LIGHT RAIL PERMITTING CITIZEN ADVISORY COMMITTEE

ADVISORY DOCUMENT - RECOMMENDATION TO THE DIRECTOR - SOUTH BELLEVUE SEGMENT DESIGN AND MITIGATION PERMIT July 2, 2015

East Link Package Offers 1

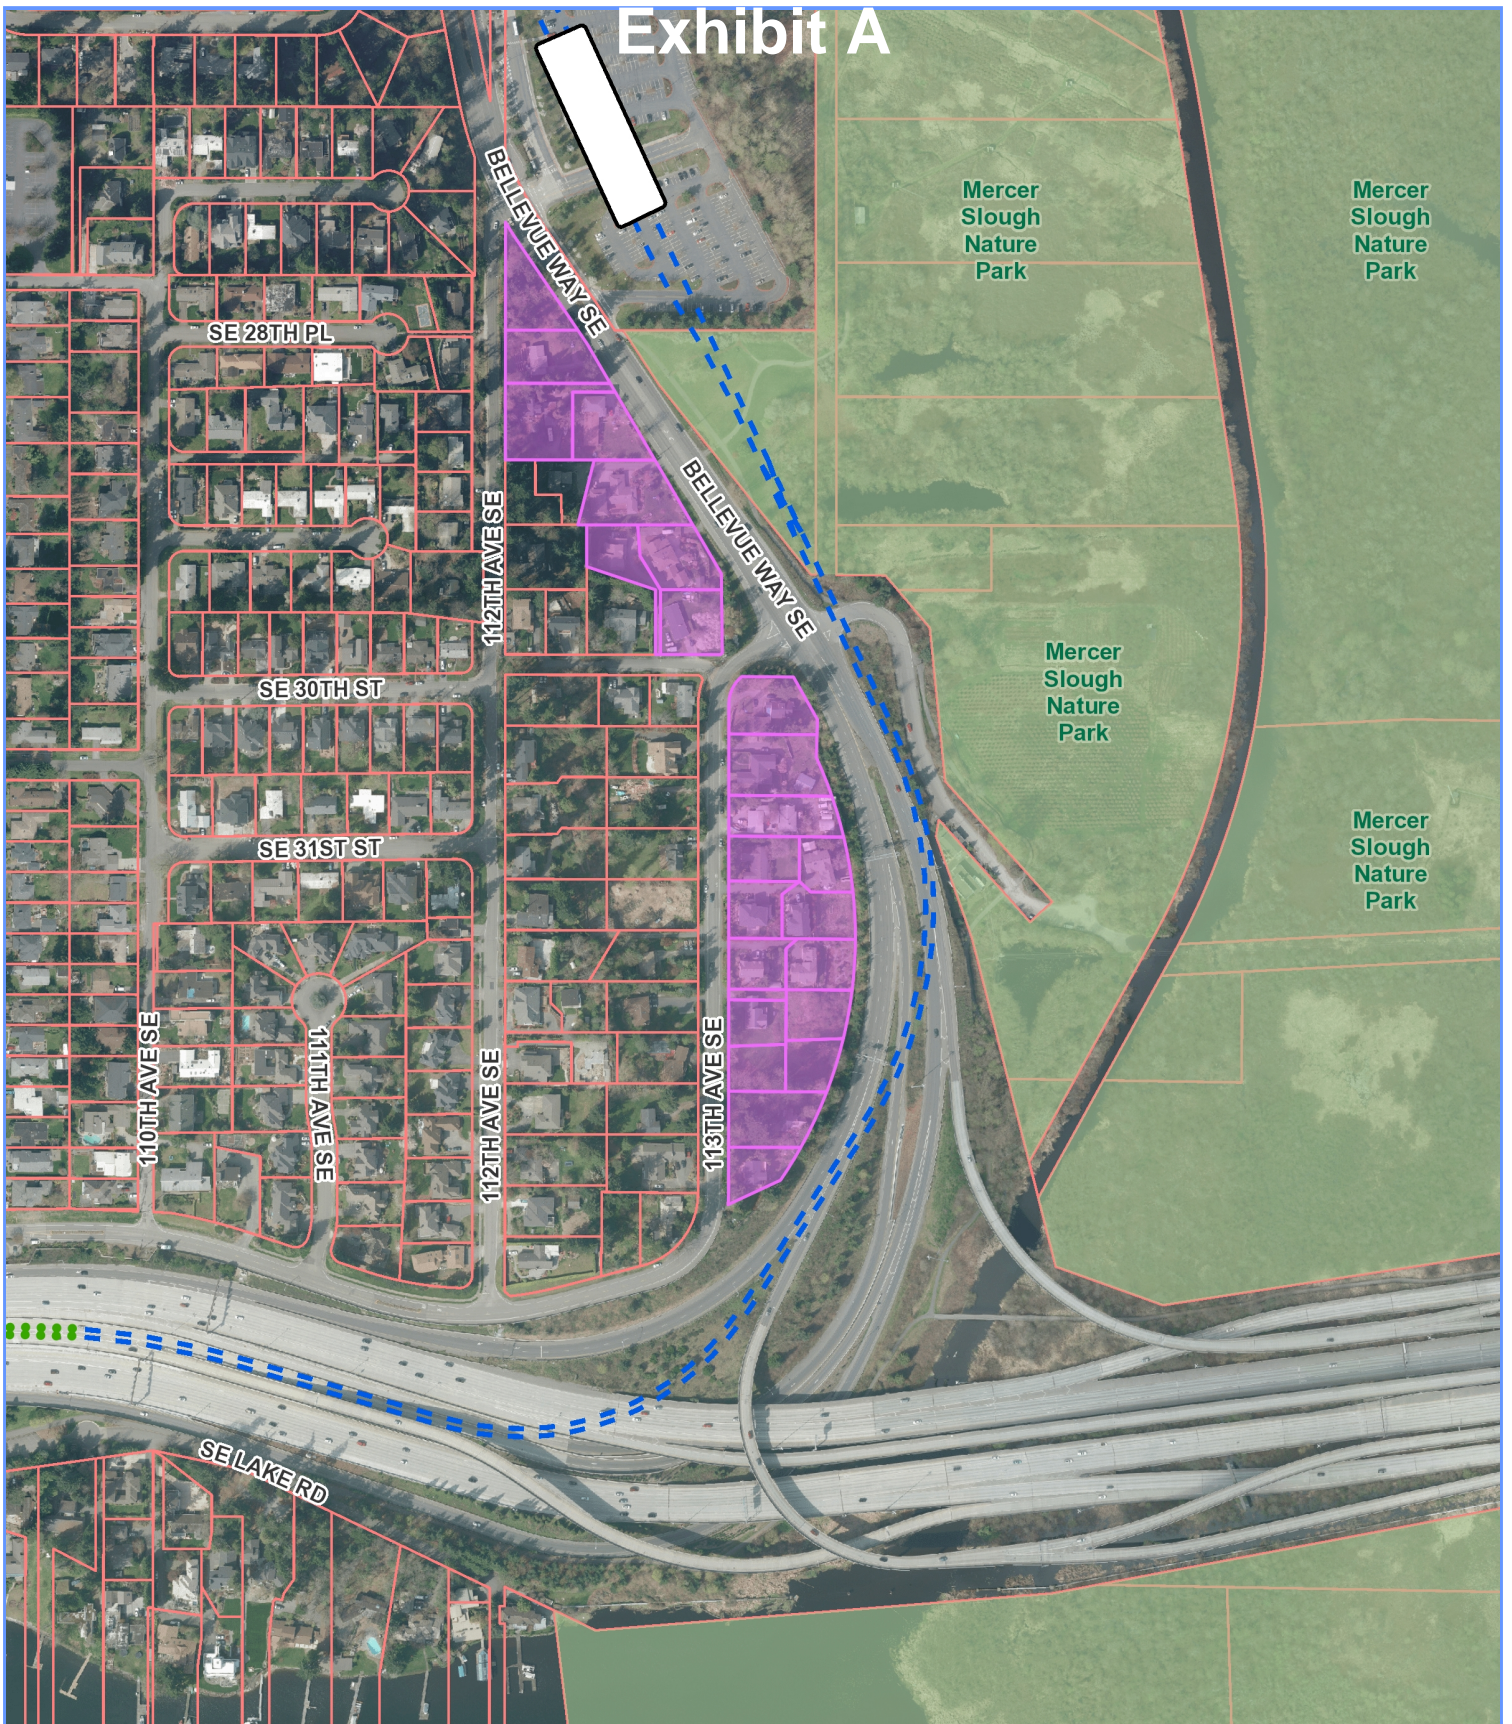
Recommendation: Prior to construction, the CAC recommends that Sound Transit offer “Residential Sound Packages” for the frontline homes along Bellevue Way and 112th where noise walls will have no impact or construction sequencing prevents the early installation of the noise walls. Frontline properties are identified on the attached sketch.

- The CAC recommends that a small viewing platform be created on the top garage deck to allow for views into the Mercer Slough Nature Park.
- Prior to construction, the CAC recommends that Sound Transit offer “Residential Sound Packages” for the frontline homes along Bellevue Way SE and 112th Ave NE where noise walls are not planned, feasible, or effective, or where construction sequencing prevents the early installation of the noise walls. This should include the frontline homes at both street level and along the top of the hillside on Bellevue Way SE per attached Exhibit A.
